1711 20th Avenue | 1715 20th Avenue

Design Review MUP Recommendation Packet | Project #3029632, #3029633 | February 13, 2019

① Street View looking Southwest

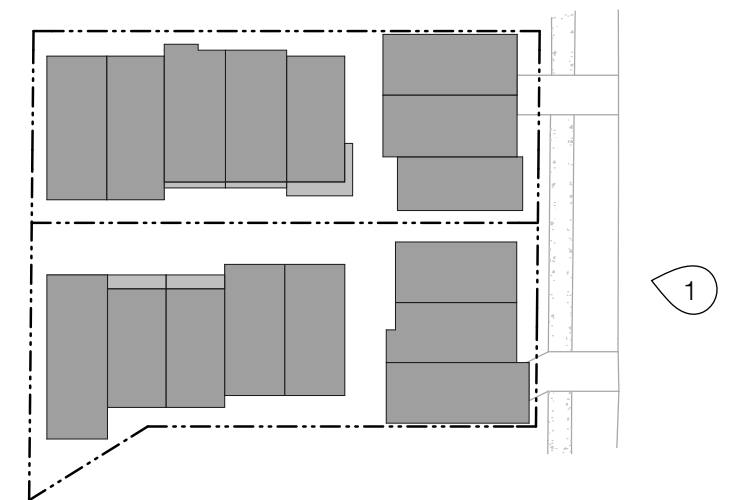
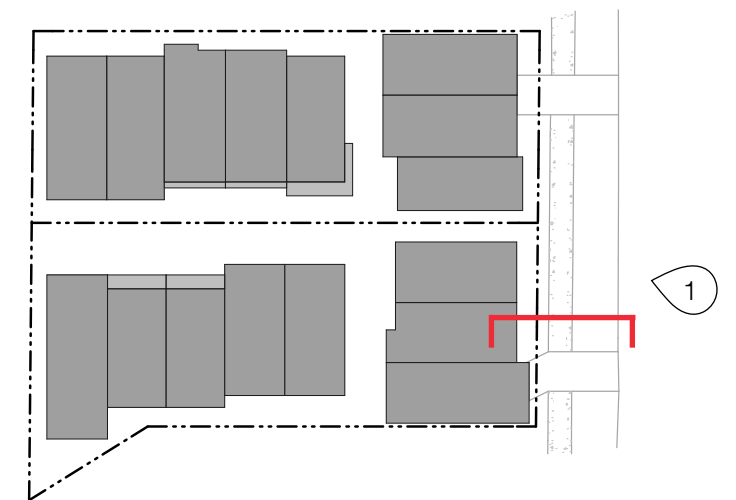
MASSING / HEIGHT, BULK, AND SCALE

- The preferred Option 3 has been developed in conjunction with the Board's guidance and has maintained the overall scale of the project. The design response addresses guidance regarding height and the monolithic nature of the four-story expression at the street.

- The site plan has been updated to relocate the below grade parking garage to be accessed from 20th Avenue. The rear townhomes have been turned to face inward, creating a large continuous courtyard space for residents and visitors.

- Its design is also improved by incorporating upper-level setbacks, changes in height and shifts between adjacent units in plan, all of which include strategic material variation.

- (A) Brick is grounded and distributed between two volumes
- (B) Mass has been shifted to provide upper level setbacks and variations in height

① View looking West up central stair

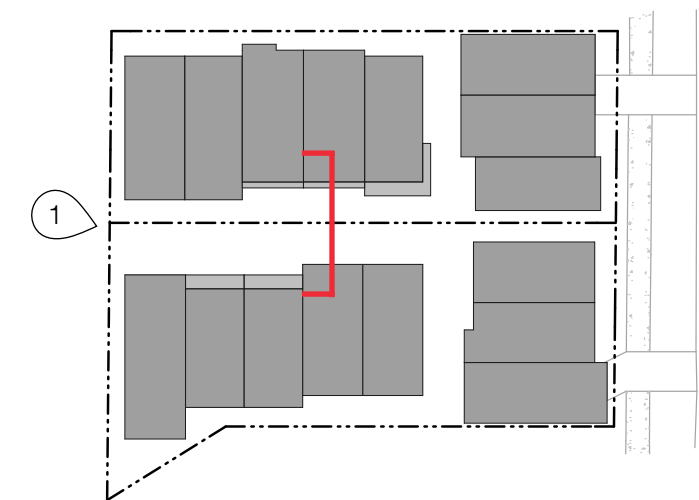
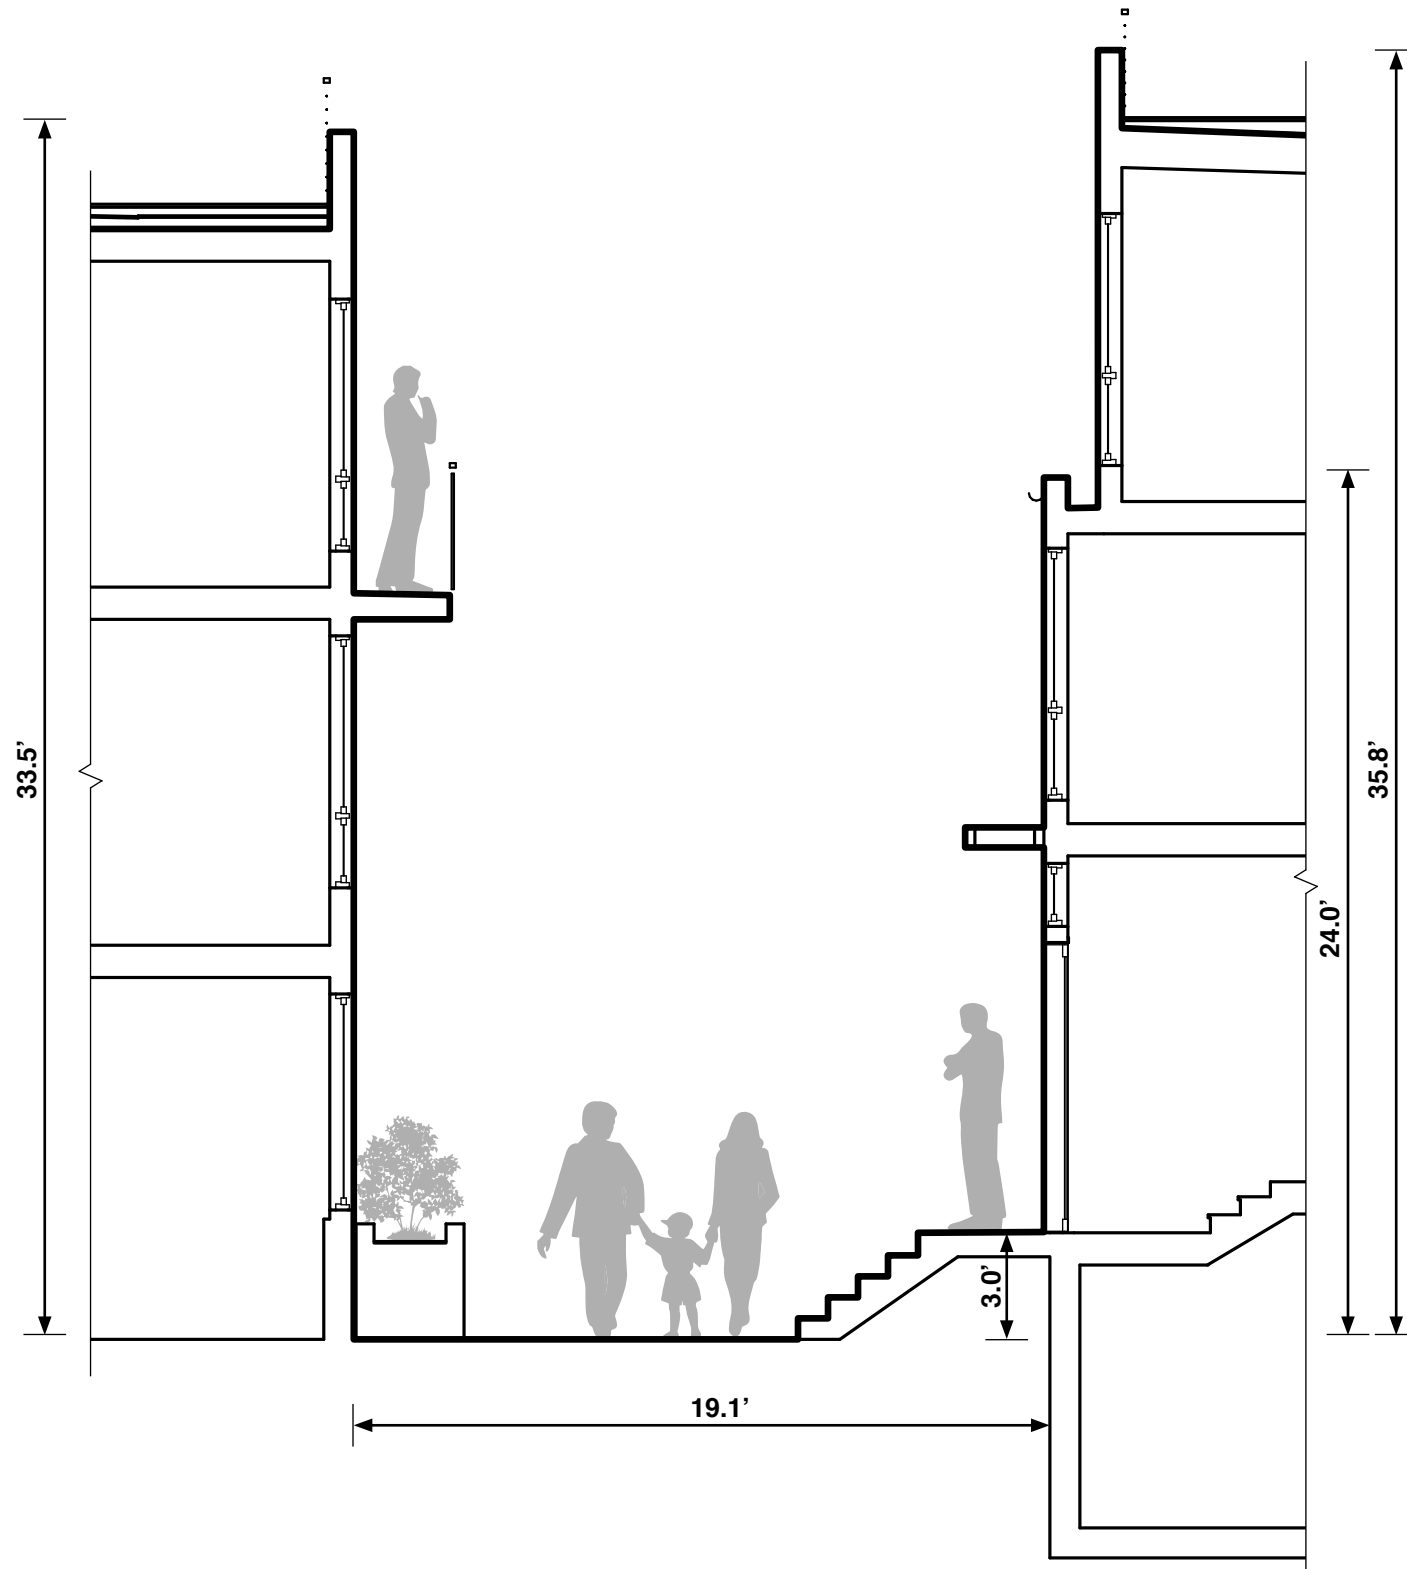
FACADE COMPOSITION AND STREETSCAPE

- The courtyard pedestrian entry path has been widened by 2 feet in order to provide a stronger visual connection between the street and the courtyard. This results in an 8-foot wide space, where visitors and residents can circulate, gather and interact, creating an informal space between the active streetscape and courtyard beyond.
- The courtyard pedestrian entry features a steel arbor that steps up following the landings of the stair that highlights the shared entry and contributes to clear wayfinding to the courtyard for all residents and visitors.

EXTERIOR MATERIALS

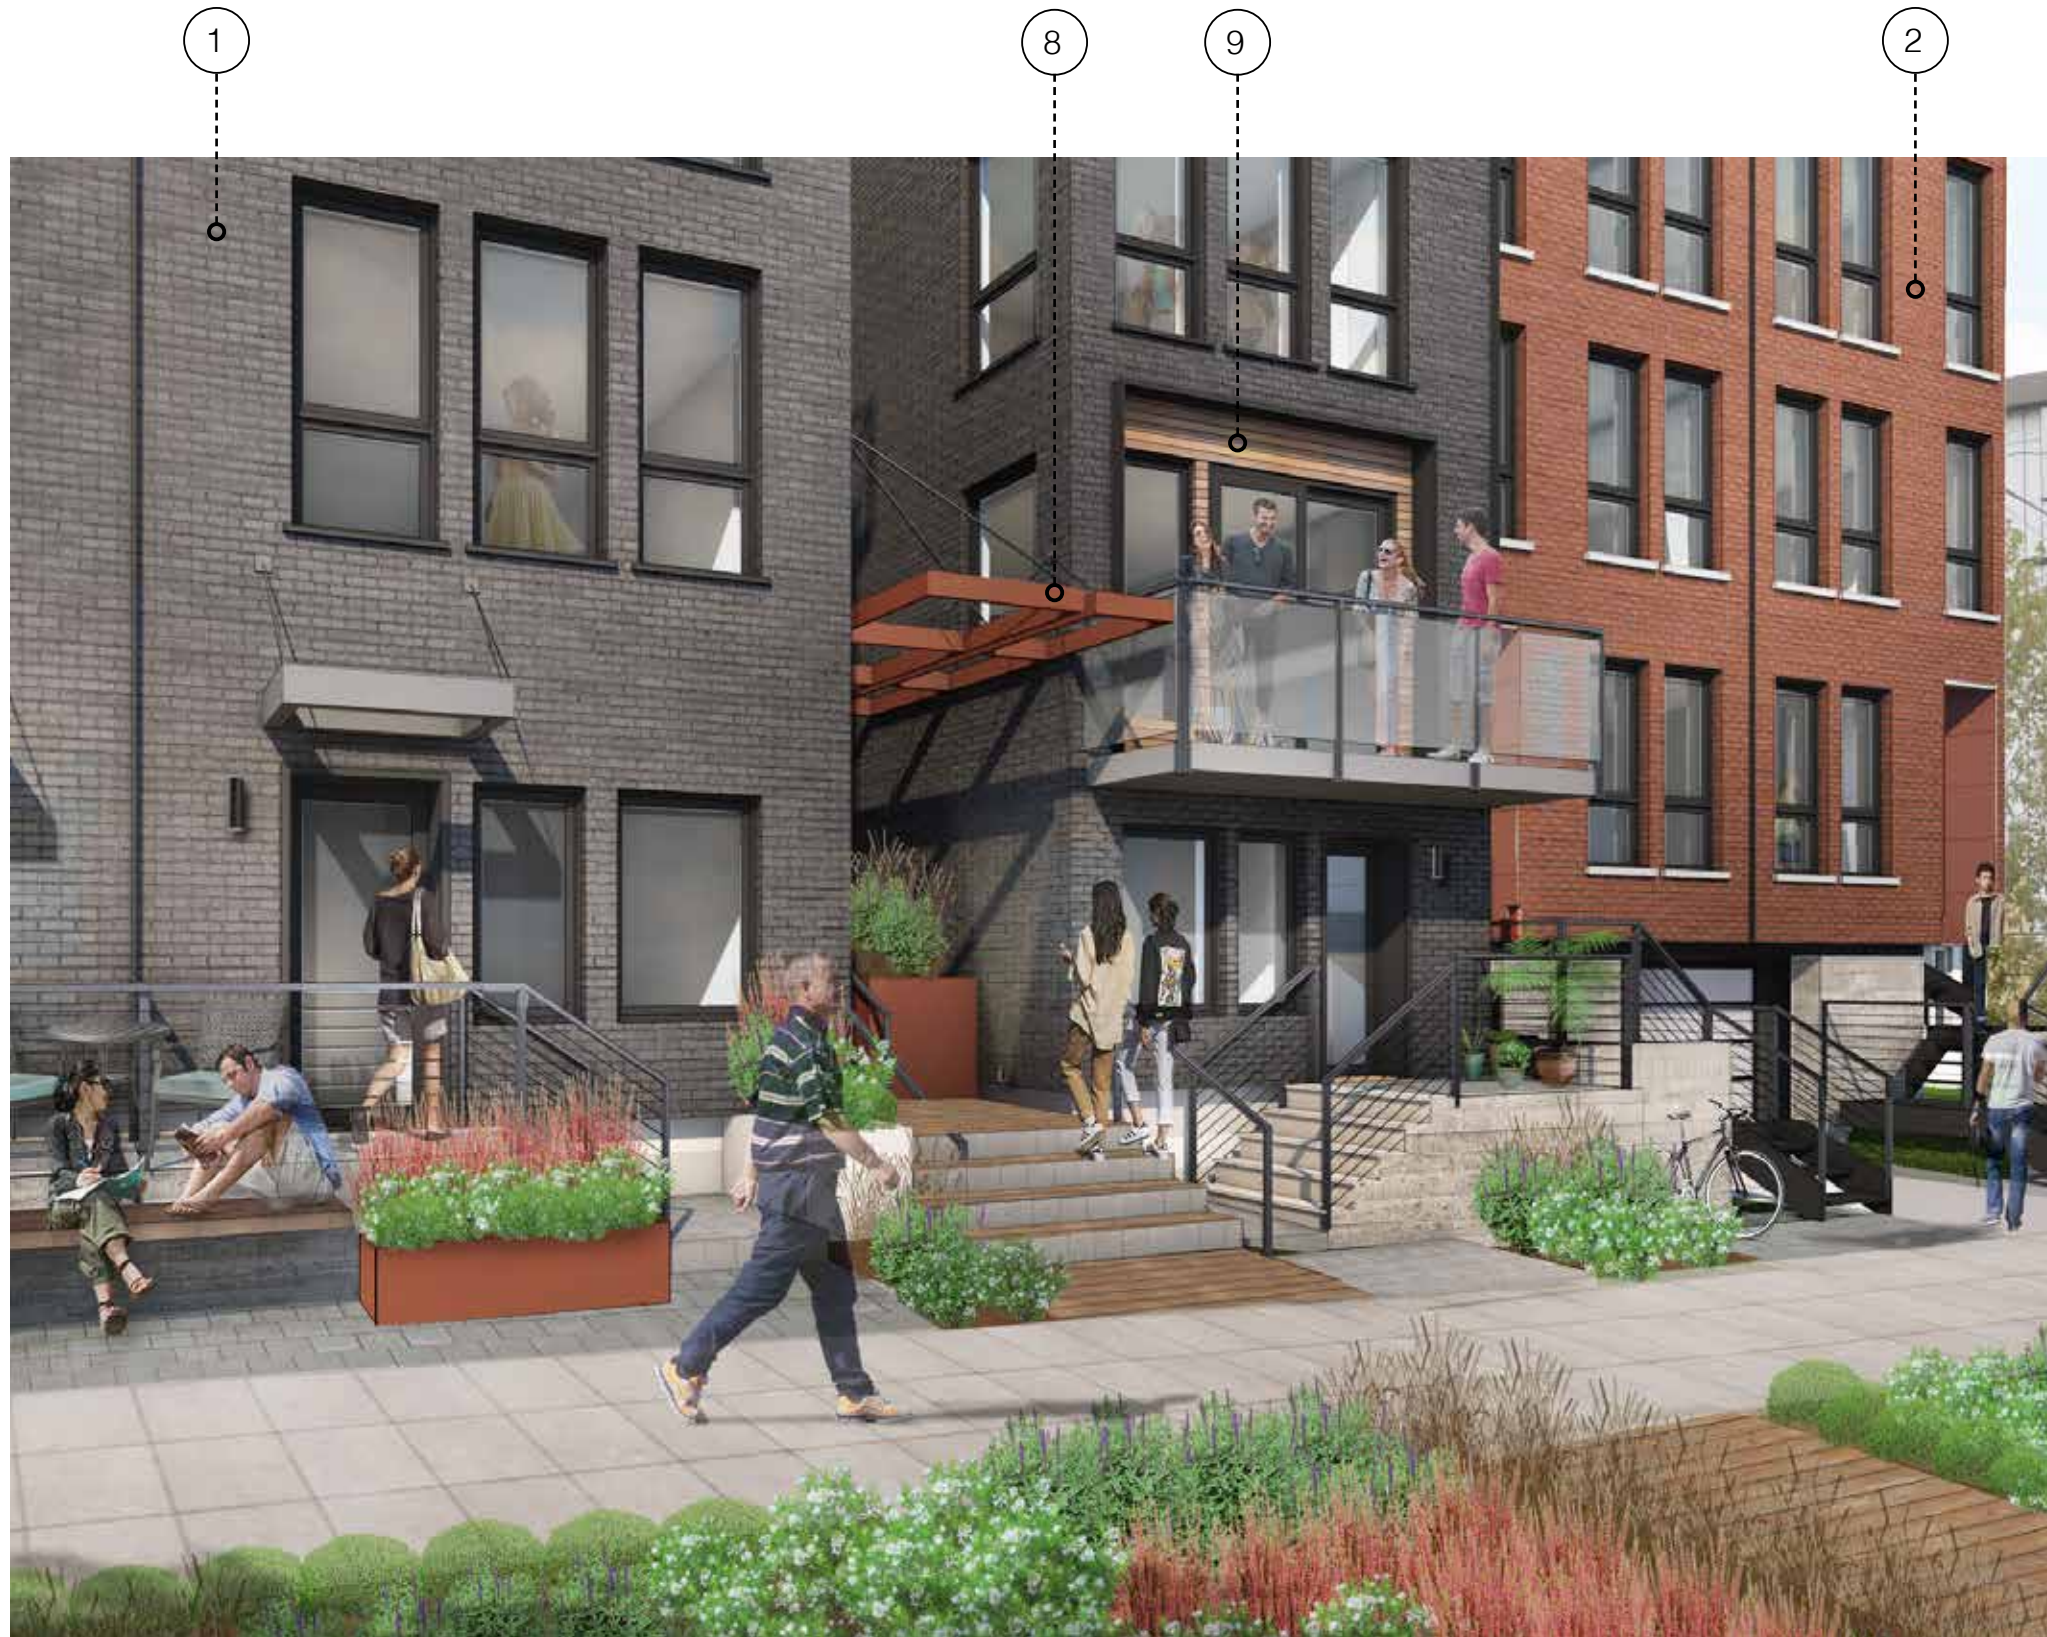
The Board appreciated the high-quality materials evident in the 20th Avenue character sketch and encouraged the applicant to retain this approach

- High quality materials are critical to the success of the design proposal. The 20th Avenue sketch from EDG proposed masonry and wood and this approach has been retained for the project.

- Brick is now proposed at all unit street-facing facades, which is more consistent with the rowhouse typology the project uses as a precedent. The brick extends from street level for three to four stories at all units, with a contrasting material at the fourth floor or at the lower level as an “infill” element similar to one of the precedent images from EDG. The biggest change is that the brick extends to grade at four of the six units with the brick sitting on a base of board-formed concrete at the remaining units. This provides high quality, durable materials at all units adjacent to the pedestrian realm. This replaces areas of painted cement board panel. The extension of the brick to the street level results in grounding the masonry material at the base of the façade.

- In response to the large green buffer proposed in the planting strip, we are proposing a reduced setback at a few units, unit 3 on the north parcel and units 1 and 2 on the south parcel. This results in a better design solution with brick continuous at these units at the street level. We are requesting a small departure for these, similar to EDG and provide more documentation of the relationship of the stoop to the street level. In addition, we are requesting a departure for a portion of sight triangle and have proposed driveway made of pavers to slow vehicular traffic down in and out of the shared garage.

- The steel arbor at the shared access stair between the structures is powder coated red to complement the brick facades and provide a clear wayfinding path to the courtyard. All entry canopies and decks at the courtyard are also highlighted red to match the stair arbor. At the street facade all canopies and decks are lighter, to contrast the brick and allow the courtyard arbor to stand out. These detailed elements add visual interest to the project, along the street and courtyard facades.
